SITE PLAN REVIEW AND APPEARANCE BOARD STAFF REPORT

Pierre Delray II

Meeting	File No.	Application Type
September 28, 2022	2022-080-SPM-SPR-CLIV	Class IV Site Plan
Property Owner		Agent
Pierre Delray Two LLC		Dunay, Miskel, Backman LLP

Provide a recommendation to the City Commission regarding three requested waivers in association with a Class IV Site Plan Modification to expand the previously approved three-story mixed-use building and parking garage.

Waiver #1, Side Interior (West) Setback Reduction

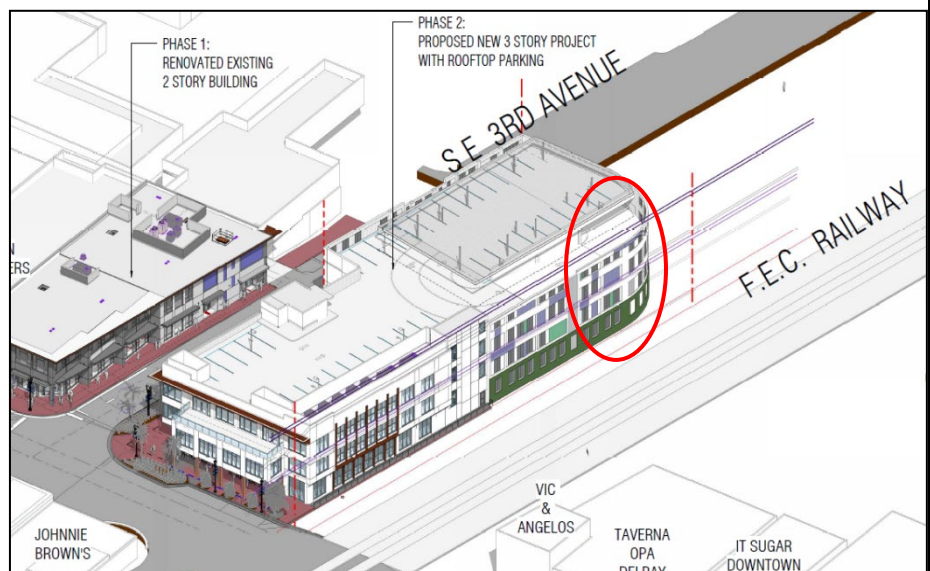
Pursuant to **LDR Section 4.4.13(D)(1)(b)(2)(b)**, Buildings with openings, including doors, windows, and glass wall materials, facing an interior side property line must setback a minimum of five feet from the property line.

The applicant has requested a side setback of 2 feet, 3 inches from the west interior property line (see area circled in red). This waiver had been previously granted for the initial Class V Site Plan application. However, with the revision proposed per the Class IV Site Plan Modification, the reduced setback will occur within the southern parcel that was not originally included within the scope of work, and as such, the previous waiver approval does not apply to the newly acquired parcel. Therefore, the applicant is requesting the waiver so that the building setback for the portion of the structure that will be located within the southern parcel is consistent with the setback as approved for the portion of the building included within the original parcel to the north.

The impact of the reduction is minimal given that the area to the west of the property is occupied by the FEC railway line. As such, no building will be constructed within the adjacent property to the west and the need for increased clearance between buildings with openings on abutting parcels is therefore not applicable to this site. Further, facades without openings are permitted at a zero-foot setback. The waiver appears to meet the intent of the applicable criteria and is not anticipated to produce any adverse impacts.

Waiver #2, Additional Story above Arcade

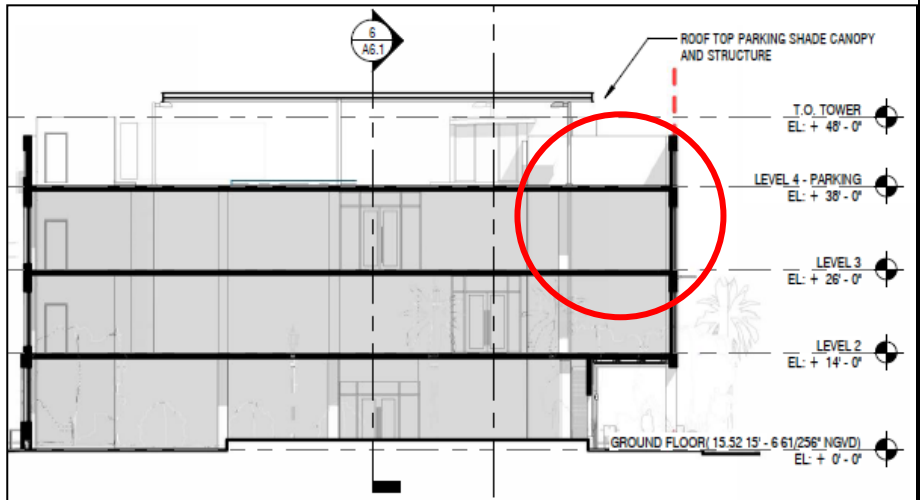
Pursuant to **LDR Section 4.4.13(E)(4)(f)(1)(f)**, *The arcade extending over the public right-of-way may contain a second story or incorporate roof terraces; additional stories are not permitted.*

The applicant has requested the ability to extend the arcade beyond the second story to provide an additional (third) story, which extends over the ground floor setback area and encroaches approximately 18 inches into the right-of-way. A similar waiver was previously granted for the arcades associated with the initial Class V Site Plan application. However, with the revision proposed per the Class IV Site Plan modification, the additional story above the arcade along SE 3rd Avenue extends into the parcel to the south. As such, the previously approved waiver does not automatically apply to the additional portion of the development and the request must be reconsidered.

The third-floor addition above the arcade includes portions of the extended parking garage. The inclusion of the usable area on the second floor for both habitable space and parking is permitted by right, however the extension above the second floor to include the third floor requires a waiver. It would not be feasible to provide the requisite internal circulation for a parking structure given the limited lot width dimension without taking advantage of the area that extends over the arcade.

The requisite design criteria per the CBD standards is met, and the provision of the third-floor arcade does not compromise the CBD design guidelines with respect to the pedestrian environment. The applicant is not benefiting from the request by way of increasing the leasable square footage of the building. Instead, the request is intended to help provide needed parking, which is an amenity for future customers and ensures feasible operations. The waiver appears to meet the intent of all applicable criteria and is not anticipated to produce any adverse impacts.
